Product Change Notification

Change Notification #: 108559 - 01
Change Title: Intel(R) Carrier Grade Server TIGH2U, PCN 108559-01, Product Material, New retention mechanism for optical drive will replace the original mechanism, Reason for Revision: Update TA revision numbers
Date of Publication: January 13, 2009

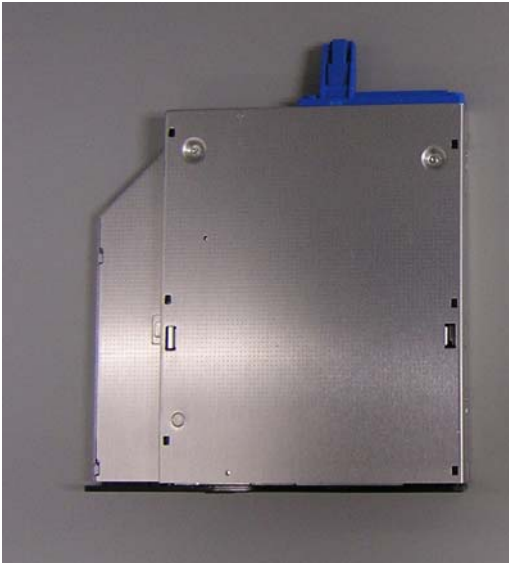
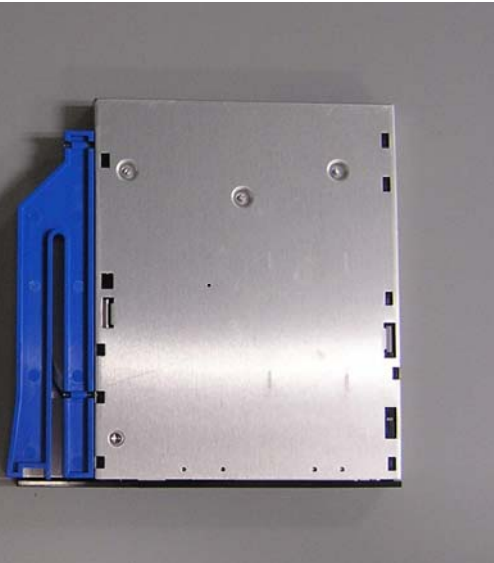
Intel has designed a new optical drive retention mechanism to simplify the installation and removal process of the optical drive. The revised retention mechanism allows removal and replacement of the optical drive without opening the top cover. The original mechanism will be discontinued and replaced by the revised mechanism.

Original optical drive retention mechanism shown on left.

Revised optical drive retention mechanism shown on right.

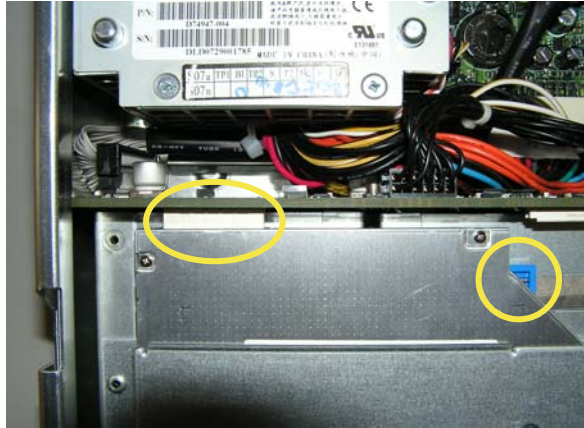
Original **optical drive** retention mechanism attached to drive (underside of CDROM shown)

Revised **optical drive** retention mechanism attached to drive (underside of CDROM shown)

Optical drive installed via original retention mechanism shown on left.

Optical drive installed via revised retention mechanism shown on right.

Optical drive can be removed by moving the lever to the left (see yellow arrow). The lever can be moved with a finger or general tool (like a screwdriver).
